From: Delcore, Lee R - DNR
Sent: Tuesday, October 27, 2020 9:17 AM
To: 'jasonp@metcofs.com'; rona@metcofs.com
Subject: FW: Additional Information required letter for Herriges Bulk Plant - BRRTS 02-67-111819
Attachments: 20201008_198_Additional_Info_Req.pdf; 4413_001.pdf

From: Ron Anderson <rona@metcofs.com>
Sent: Tuesday, October 20, 2020 3:04 PM
To: Delcore, Lee R - DNR <Lee.Delcore@wisconsin.gov>
Cc: Jason Powell <jasonp@metcofs.com>
Subject: RE: Additional Information required letter for Herriges Bulk Plant - BRRTS 02-67-111819

Subject: Site Investigation Not Approved - Additional Info. Needed for Case Closure
consideration under Wis. Adm. Code chs. NR 700-754
Herriges Oil Bulk Plant South, 215 Railroad St., Kewaskum, WI, 53040
DNR BRRTS Activity # 02-67-111819 FID # 267158760

D.2 LOCATION MAP

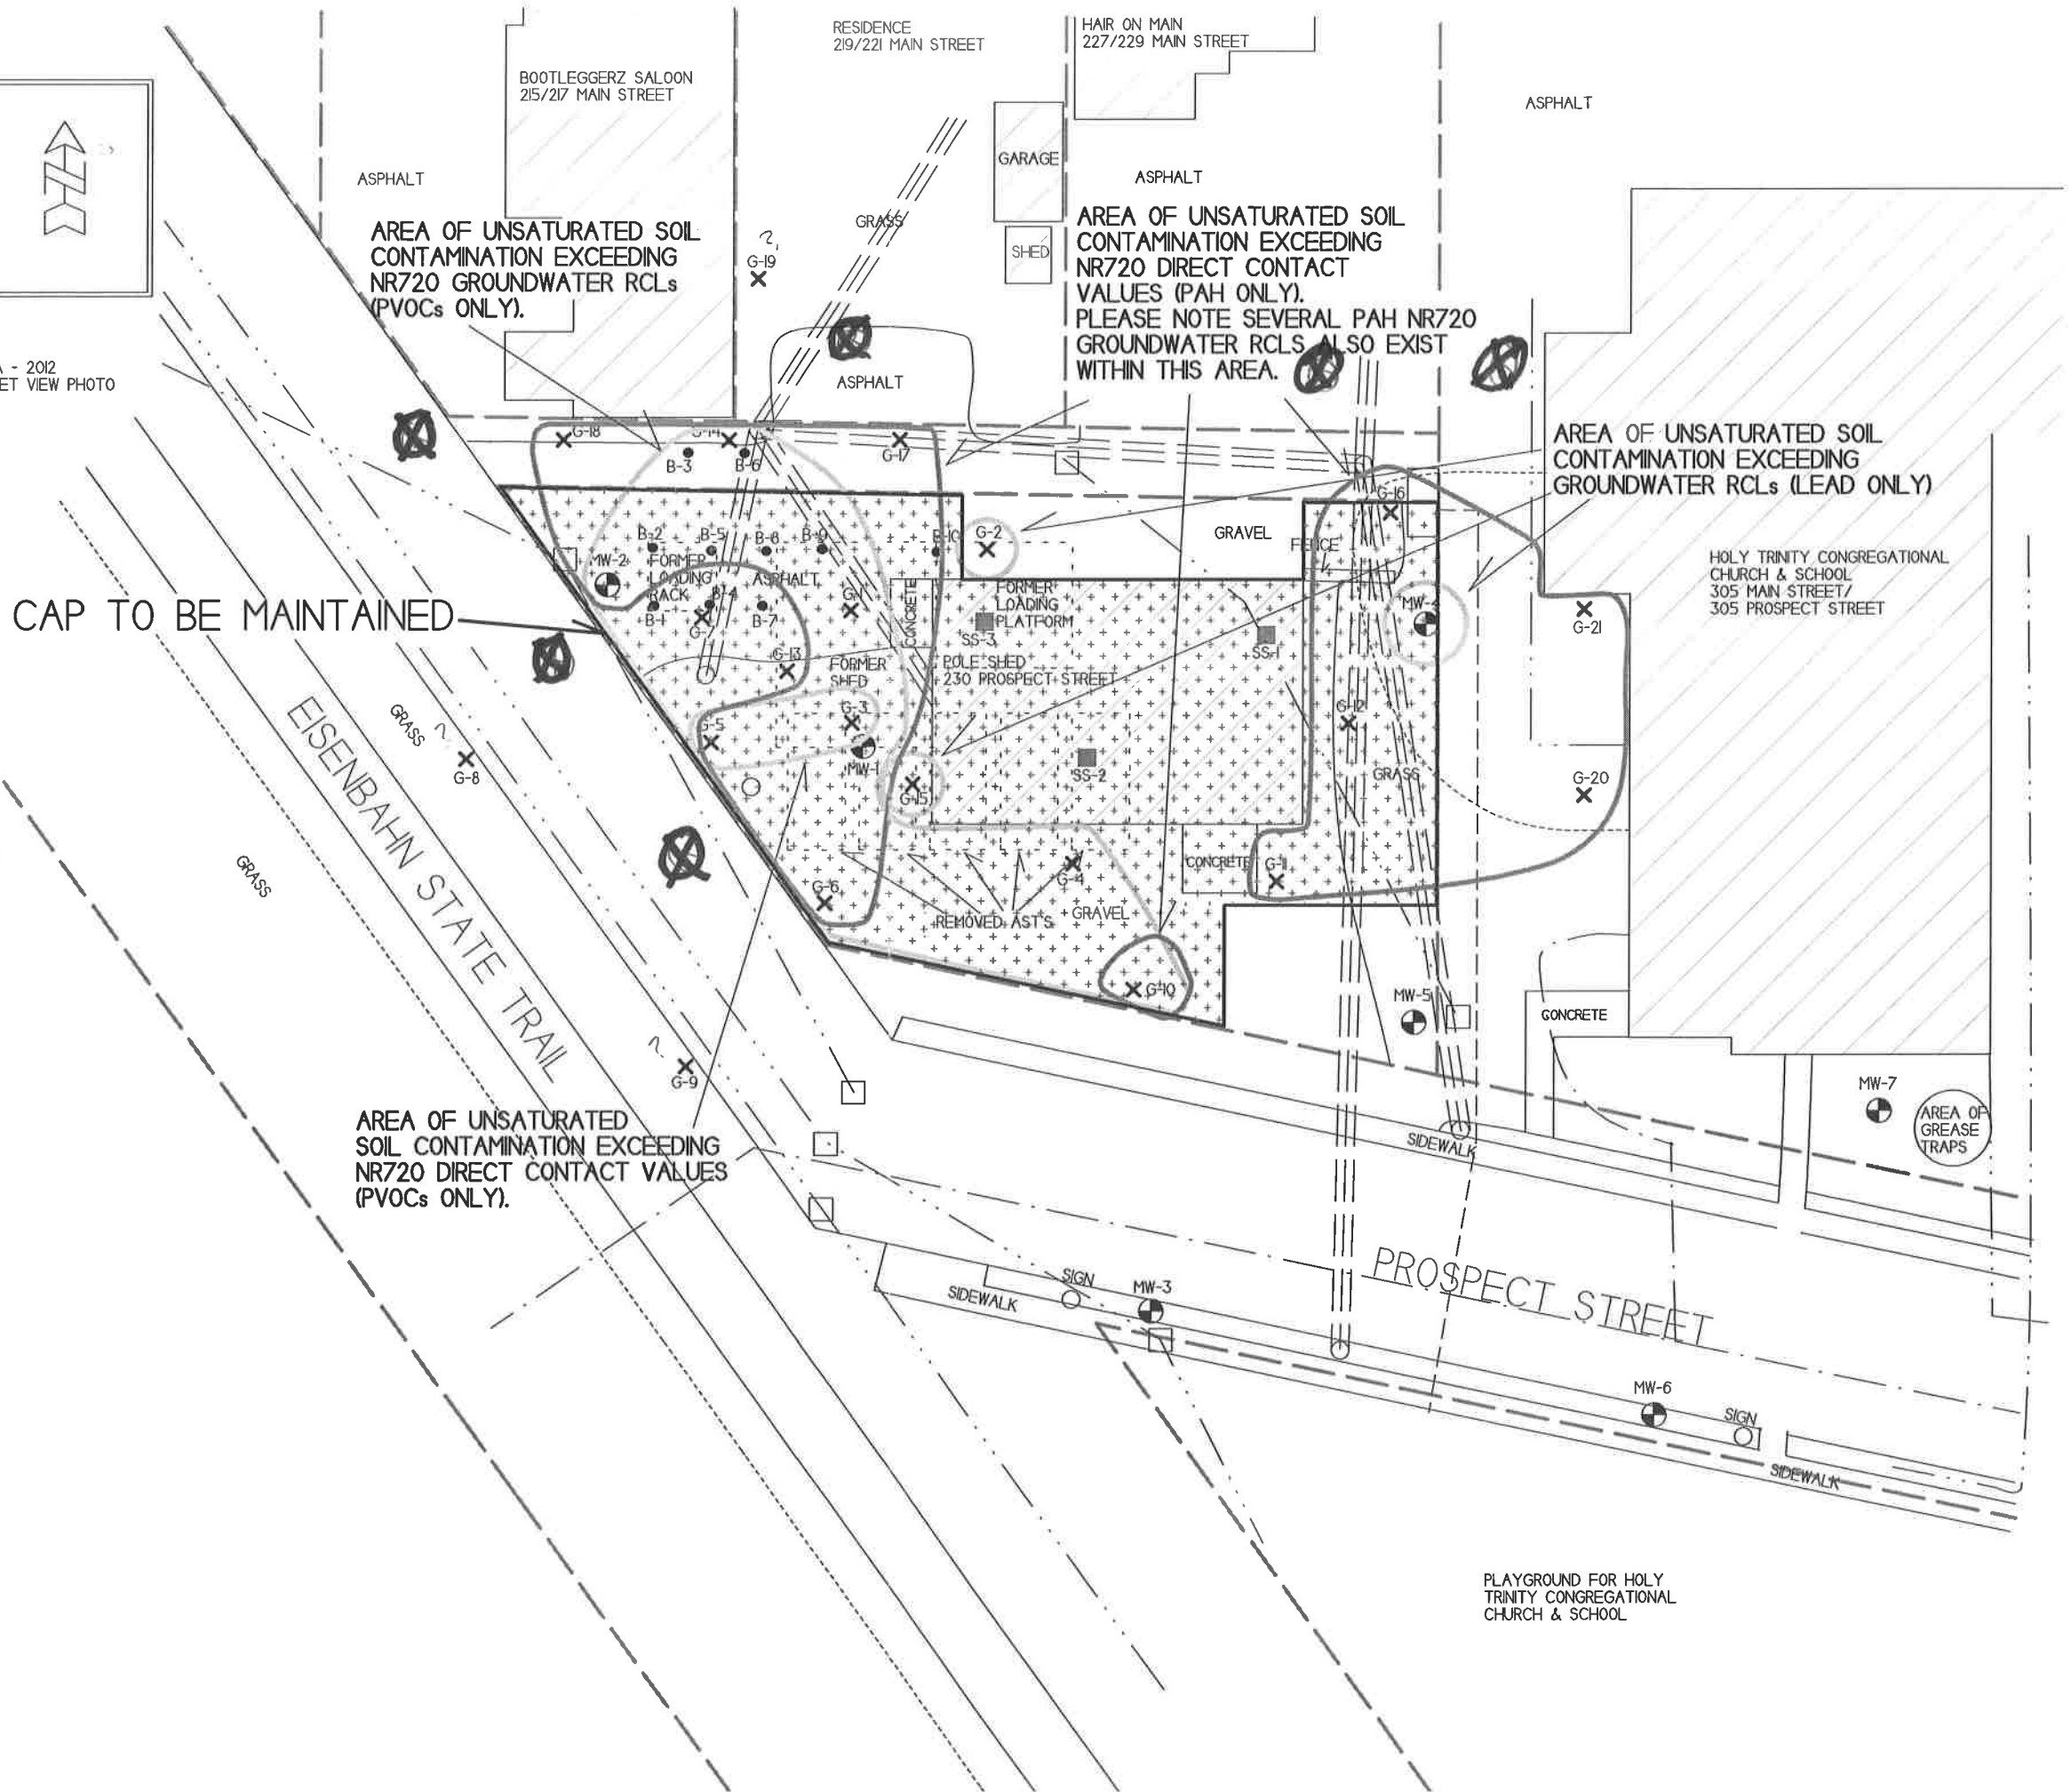
- 1) For "Degree and Extent of Soil Impacts"I have attached a map with proposed boring locations to the North and West. Are these locations satisfactory?
- 2) For "Proposed Continuing Obligations" ...How are we supposed to "show that the cap is protective"? This is something we have never been asked before. Do you want us to collect some shallow soil samples?
- 3) For "Documentation"...We are not sure how you want this plume extent to be drawn as two other nearby sampling locations (G-4 and G-15) did not have direct contact exceedences. Thus, can you put a line on a map so we can get this the way you want it.

Elevated concentrations of PAHs were found in near-surface samples, including at some off-site locations. The concentrations were at levels that exceed both industrial and non-industrial residual direct contact levels. It is unclear, based on the submittals, whether there is a distinction between the petroleum contamination from the historic bulk plant operations at the site and any imported soil fill material. In either case, more soil sampling is warranted to define the degree and extent, including off-site to the north and the west.

While a structural impediment does not appear to be warranted based on samples that were able to be collected beneath the pole barn, the proposed cap of grass and 2-3 inches of gravel on other areas of the site is not necessarily adequate. The adequacy of the cap, both on and off-site, must be evaluated and shown to be protective.

As far as the proposed locations of the off-site samples, they appear appropriate to help define degree and extent of near surface impacts related to the bulk plant operations. Again, shallow samples demonstrating that 2 feet of clean material would be appropriate to demonstrate protectiveness of a cap. Deeper samples are appropriate for demonstrating vertical extent and/or migration via groundwater.

As far as drawing of the lines, that can be tricky in cases involving heterogenous fill. As fill material does not represent a point source, just because you have a clean sample in one area, it is very difficult to say that one foot over the fill material is not impacted. In this case, you have multiple, significant direct contact exceedances of PAHs at different locations across the site. If the conceptual model is that the PAH impacts are primarily from a contaminated fill source, then the cap/line should include the entire area of fill material or up to the property boundaries if the fill material is determined to extend across the boundaries.

So all that being said, shallow samples showing the degree and extent of the PAH impacts on-site and off-site are warranted. In order to close the site, the continuing obligation of a surface cap that is protective from direct contact exposure would need to be demonstrated. This can be accomplished through demonstrating a "clean" layer above the impacts and demonstrating how that layer will be maintained, installing a clean layer above the impacts, or installing a protective barrier above impacts (i.e. pavement).
